# **Proposed Redevelopment of the Marrickville Metro Shopping Centre**

## **Review of Traffic Management and & Accessibility Plan**

Prepared by  
**Fred Gennaoui**

**For Department of Planning &  
Infrastructure**

Bus Terminal Design  
in Edinburgh Road

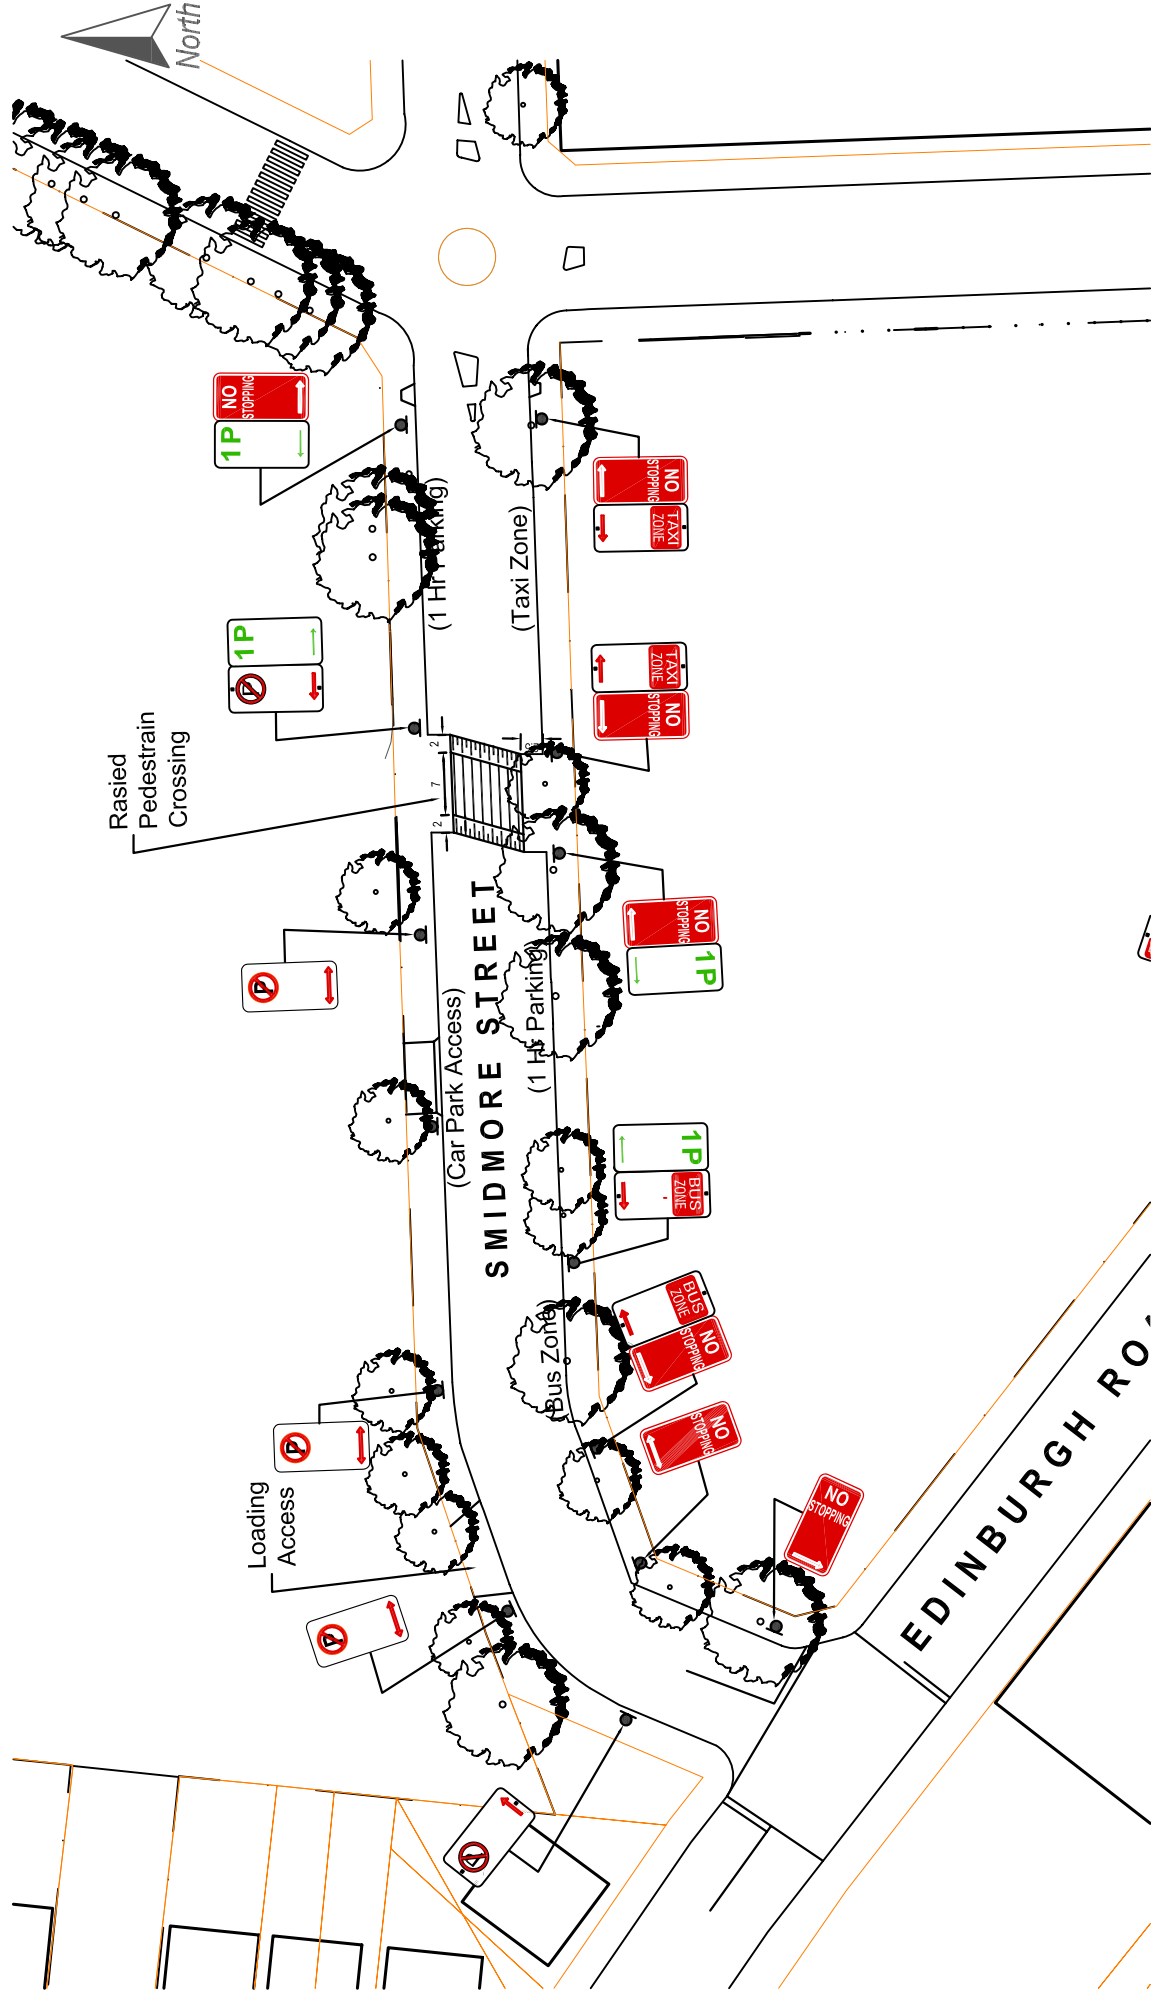
A roundabout is proposed at this location; the roundabout is not required to cater for increased traffic along Edinburgh Road. It is required to cater for buses arriving from the east making a U-turn at this roundabout to access the new bus terminal on the northern side of Edinburgh Road (refer section 2.6.1). The roundabout should therefore be designed accordingly.

The existing roundabout is to be retained. The roundabout would allow buses travelling from the west along Edinburgh Road to U-turn after departing the proposed new bus terminal. It should be checked to ensure that Metro buses (14.5m long) can make this manoeuvre.

- A new bus station on Edinburgh Road, as illustrated in **Appendix J**, shall be constructed to include kerb adjustments and line marking to provide three (3) bus stops plus a quality sheltered passenger waiting area. The design shall be to the satisfaction of the Marrickville Local Traffic Committee in consultation with the State Transit Authority.
